MICROCHIP PIC18F2420/2520/4420/4520

PIC18F2420/2520/4420/4520 Rev. B4 Silicon Errata

The PIC18F2420/2520/4420/4520 Rev. B4 parts you have received conform functionally to the Device Data Sheet (DS39631E), except for the anomalies described below. Any Data Sheet Clarification issues related to the PIC18F2420/2520/4420/4520 will be reported in a separate Data Sheet errata. Please check the Microchip web site for any existing issues.

FIGURE 1: SCK PULSE VARIATION USING TIMER2/2

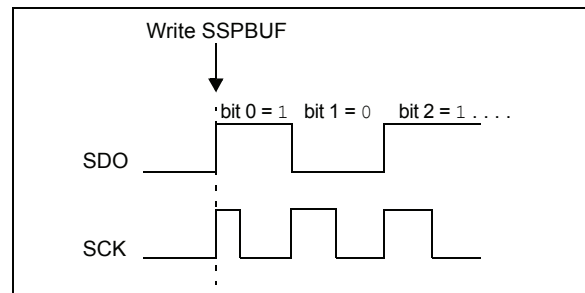
When the SPI is using Timer2/2 as the clock source, a shorter than expected SCK pulse may occur on the first bit of the transmitted/received data (Figure 1).

To avoid producing the short pulse, turn off Timer2 and clear the TMR2 register, load the SSPBUF with the data to transmit and then turn Timer2 back on. Refer to Example 1 for sample code.
